UNITED STATES ENVIRONMENTAL PROTECTION AGENCY
REGION I
1 CONGRESS STREET, SUITE 1100 (HBT)
BOSTON, MASSACHUSETTS 02114-2023

**Re: Final Report on Monitoring Event 14 - April 1999 for sites 1, 3 and the Eastern Plume,
Naval Air Station, Brunswick, Maine**

Michael S. Barry
Remedial Project Manager
Federal Superfund Facilities Section

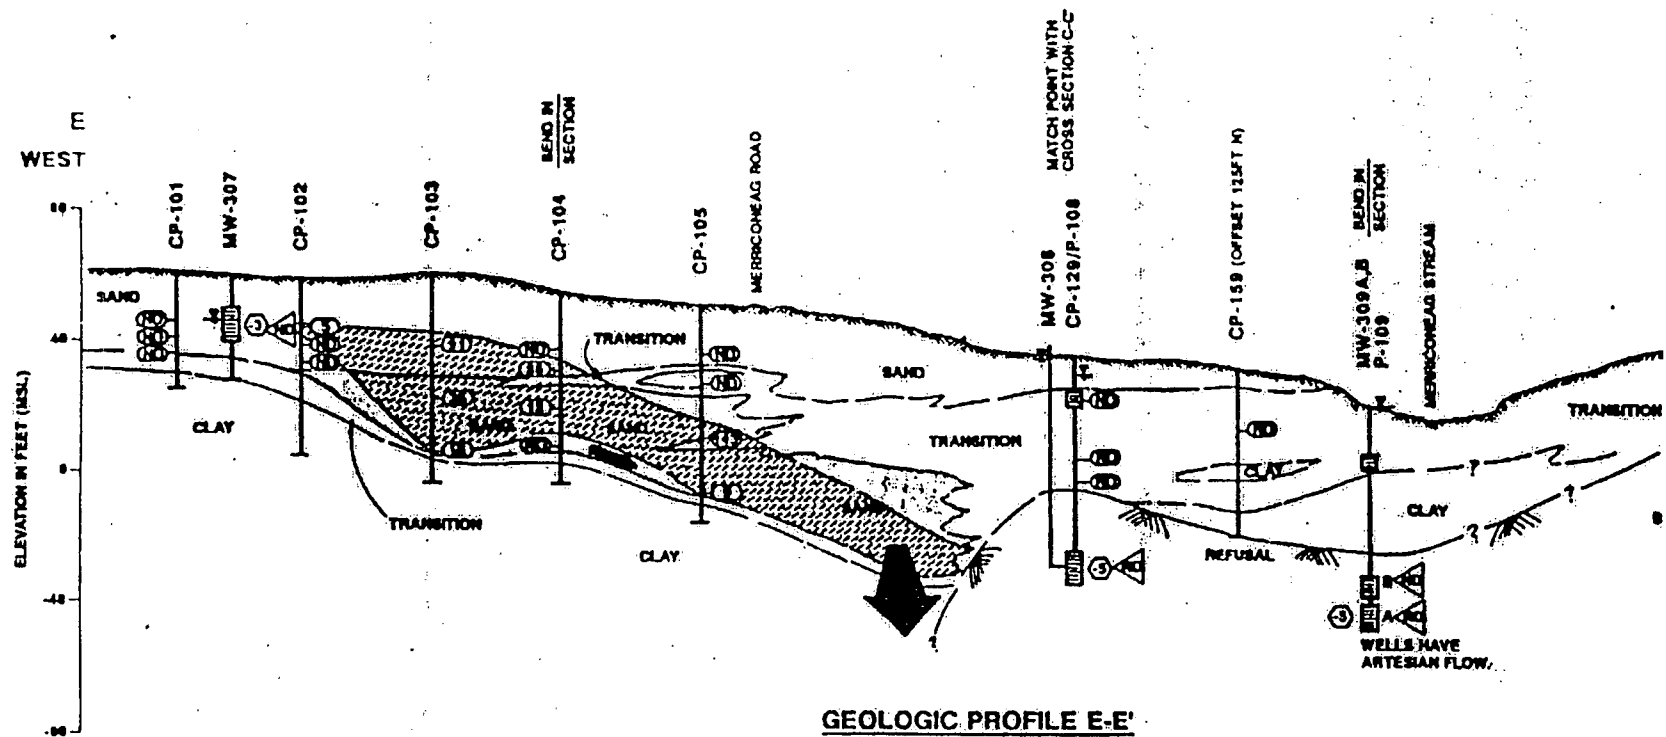
- a. **Figure 1** (enclosed in hard copy letter only) contains a geologic cross-section that includes MW-308 and MW-309B. Contrary to the interpretation of Figure 1, there is no physical evidence to indicate that coarse sand directly contacts bedrock near MW-308. Rather, the transition layer is interpreted to enclose the coarse sand on 3 sides, to the North and South and may do so here as well. The significant confining nature of the transition layer may have resulted in the lack of significant contamination observed in surface water sampling, and at MW-308 and MW-309B. Furthermore, the 2 wells MW-309A and MW-309B, installed in bedrock capped by clay, demonstrate significant vertical flow upward, from a source likely within the sharp bedrock rise to the East, rather than from a source in the West.

Figure 1. The geologic cross-section from the 1991 E.C. Jordan study that includes MW-309B, and depicts deep plume flow to the South, contrary to the current 2 dimensional flow-net. The current flow-net predicts deep flow to Merriconeag Stream by assuming that shallow bedrock well MW-309B is representative of the deep flow system. Very likely, the deep coarse sand is isolated from MW-309B by the clay and transition layers.

- b. **Recommendation.** Until contamination is discovered East of the deep coarse sand layer, consider the eastern edge of the coarse sand layer to be a no-flow or very-low-flow boundary. Review the wells and piezometers available for gauging the eastern edge of the deep coarse sand, and modify the long-term monitoring plan to increase the spatial

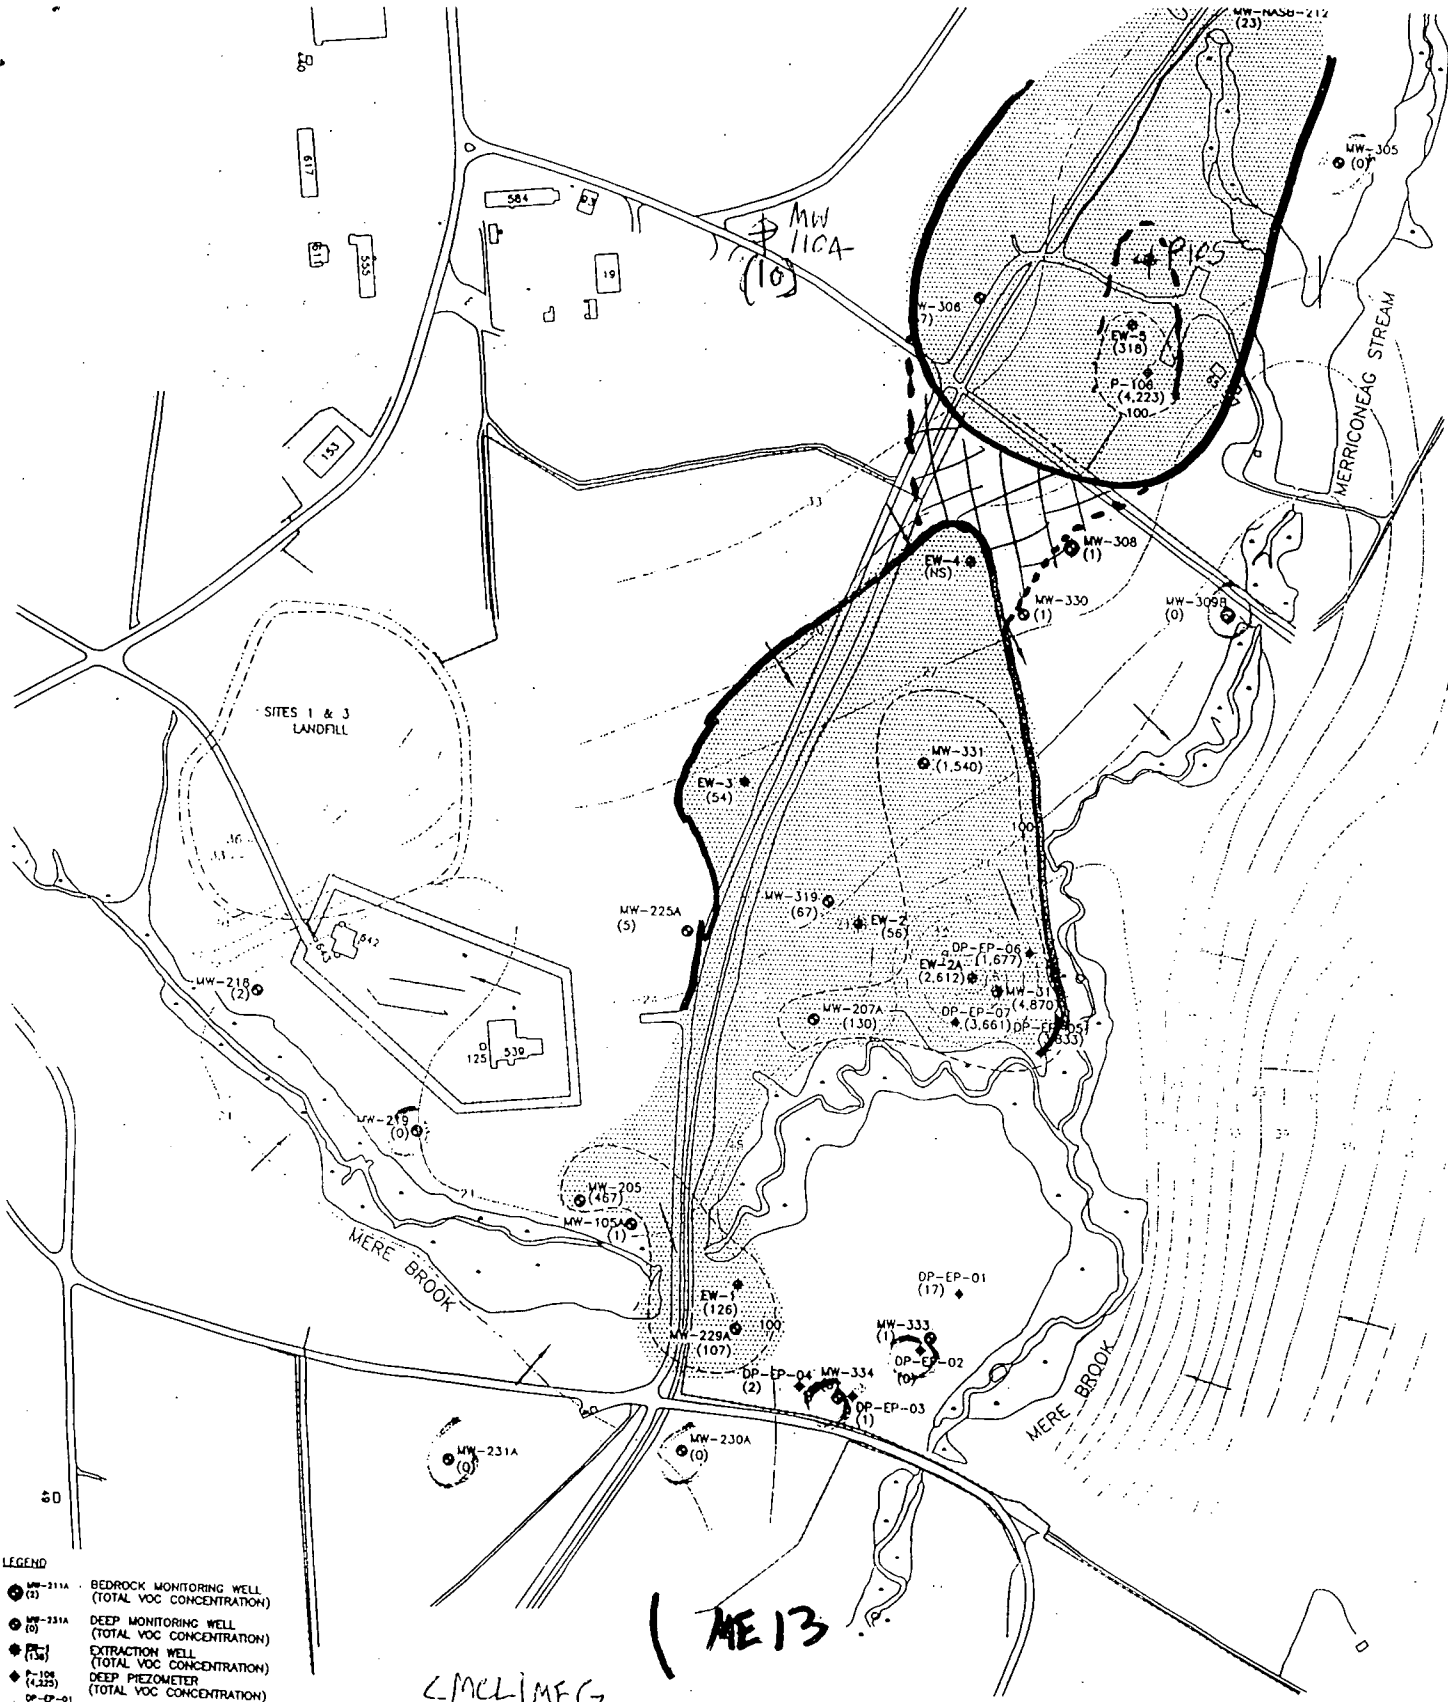
- a. Plume coverage. There is no physical evidence to indicate that the plume disappears in the 400 or so feet between EW-4 and MW-331. On the contrary, plume flow had to have historically existed in this area and was depicted as such in the monitoring event report 13 report (figure 14). Thus, it's likely a single plume exists, rather than two separate lobes.

- b. 100 ppb VOC contour. The VOC concentrations at P-105 historically tracked those of P-106; this was confirmed in the Geostatistical Assessment. Though EPA concurred with removing P-105 from the LTMP, we are certain the plume remains north of EW-5.

- c. Recommendations. Modify figure 14 in the 1999 annual and future monitoring reports by:
 - i. Extend the northern 100 ug/L contour around P-105.
 - ii. Join the two lobes into a single plume, such as a composite of figure 14 for events 13 and 14. If VOC concentrations of EW-4 or MW-331 drop-off significantly, or physical evidence is developed to indicate that the plume no longer exists between these 2 wells then the plume could again be separated into two lobes.
